Planning App Ref:	PL/2026/01506
Service Ref:	Drainage
Date:	26/08/2026

Full planning application for demolition of redundant stone barns; erection of children's nursery with new access, car parking, secure garden and associated landscape and drainage works (Class E); installation of new vehicular access and parking area to retained Southview Farmhouse, erection of replacement rear conservatory, erection of car park, associated erection of boundary treatment, and associated drainage and landscaping.

Southview Farm, Drynham Road, Trowbridge, BA14 0PJ

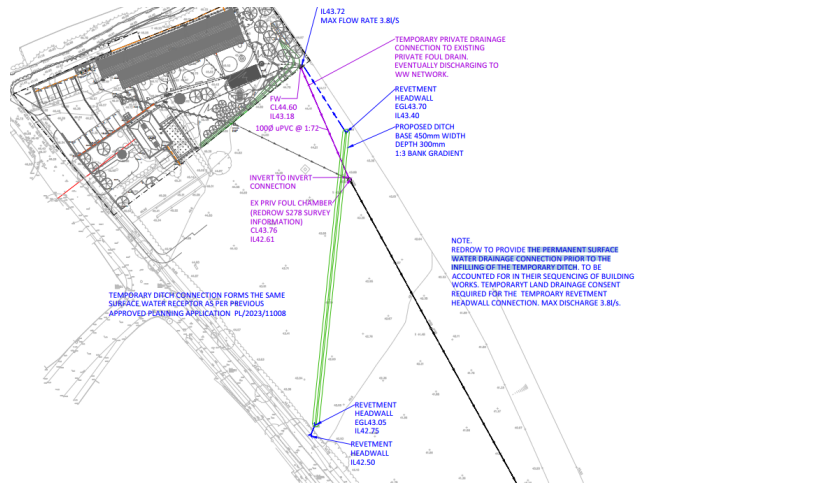
The applicant has proposed a 500mm high bund along the south-eastern corner of the site to prevent overland exceedance flows transgressing the site boundary and into future rear gardens within the adjacent Barratt Redrow development. The LLFA have removed the prior objection related to overland exceedance flow routes as this risk to future adjacent dwellings has been appropriately mitigated by the bund.

It is also noted that a surface water drainage channel has been designed to temporarily discharge to an existing roadside ditch located along the western boundary of the Barratt Redrow development site until the Redrow surface water drainage network has been constructed, and connection possible. Further details are required on this proposed solution.
